NRC DISTRIBUTION FOR PART 50 DOCKET MATERIAL
(TEMPORARY FORM)

FROM: Carolina Power & Light Co Raleigh, NC E E Utley		DATE OF DOC <u>7-24-75</u>	DATE REC'D <u>8-26-75</u>	LTR XXXX	TWX	RPT	OTHER
TO: Mr Lear		ORIG one signed	CC	OTHER	SENT NRC PDR <u>XX</u> SENT LOCAL PDR <u>XX</u>		
CLASS	UNCLASS XXXXXX	PROP INFO	INPUT	NO CYS REC'D 1	DOCKET NO: 50-261		
DESCRIPTION: Ltr trans the following: ACKNOWLEDGED DO NOT REMOVE				ENCLOSURES: Addl info for ECCS analysis....in response to our 6-18, 6-27, and their 3-14 submittal.... (40 cys encl rec'd)			
PLANT NAME: Robinson #2

H. B. ROBINSON UNIT NO. 2
LICENSE NO. DPR-23
ADDITIONAL INFORMATION FOR ECCS ANALYSIS

In response to your letters of June 18, 1975 and June 27, 1975, the following additional information is filed in order to complete your evaluation of our ECCS submittal of March 14, 1975 for the H. B. Robinson Unit No. 2 Plant. In response to the requests, Carolina Power & Light Company submits information concerning submerged valve motors within containment, single failure or operator error causing any manually controlled, electrically operated valve to move to a position that could adversely affect the ECCS, additional information c

0.4 DOUBLE ENDED COLD LEG BREAK (GUILLOTINE)

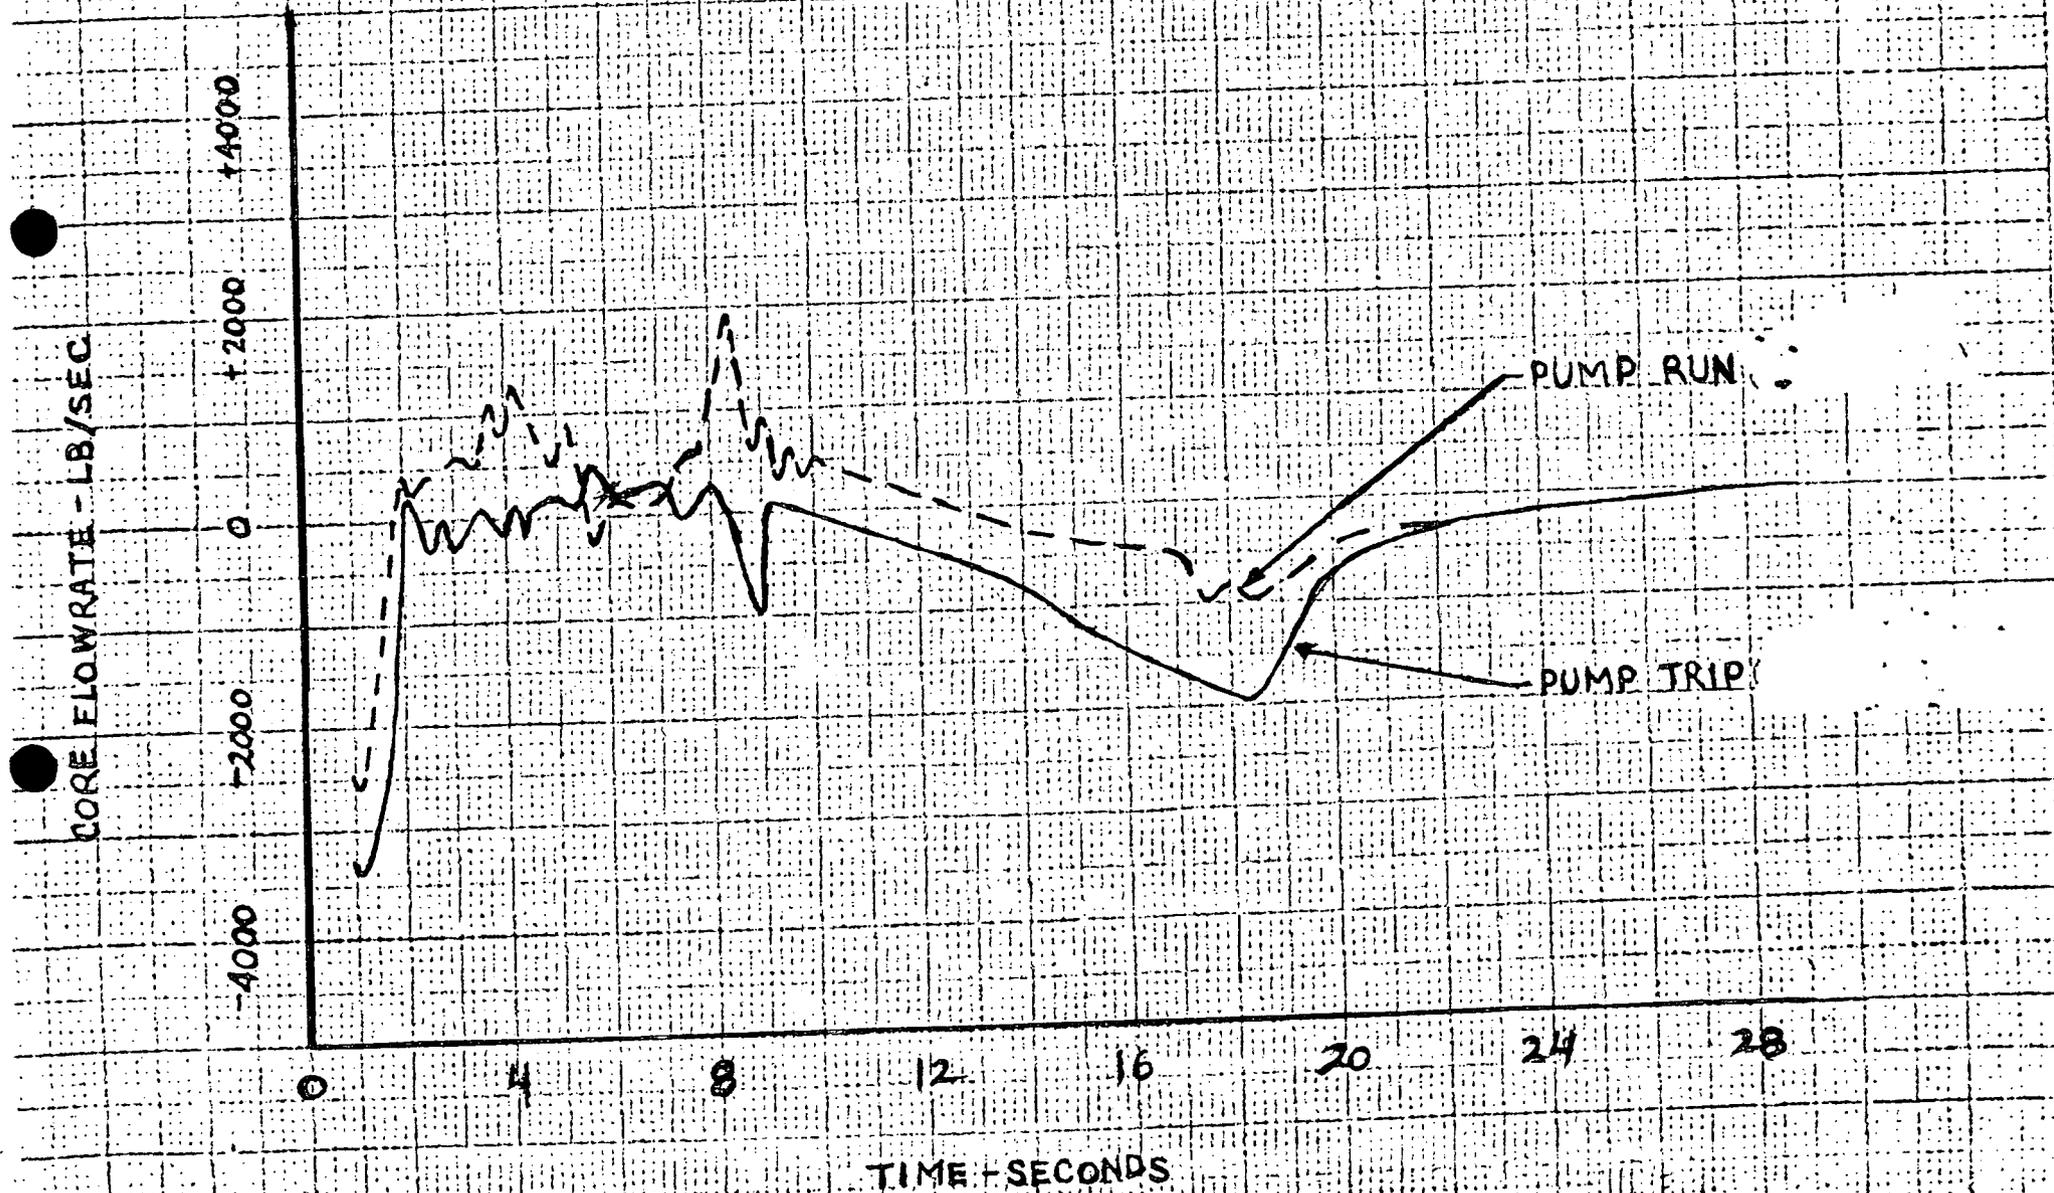
Q - For a C_D of 0.4, the generic 3-loop analysis showed a positive core flow between 10-13 seconds compared to Figure 2-9c which shows a negative core flow during this period. . .

Re-run this worst-case with reactor coolant pumps running to confirm that the expected decrease in core flow after 10 seconds (with pumps running) would not cause an increase in PCT.

A - Figure 1 shows plots of the core flow during blowdown for the Double Ended Cold Leg Break with $C_D = 0.4$ for two conditions:*

- 1) The "design" assumption that the RCS pumps trip at the time of the pipe break.
- 2) Assuming that the RCS pumps run at 100% speed during blowdown.

All other input assumptions were identical for these cases and the results are that the design case (pumps trip) had a peak clad temperature 26 F higher than the pumps run case.

This confirms the results and conclusions reached in the generic 3 loop sensitivity study presented in WCAP 8356.
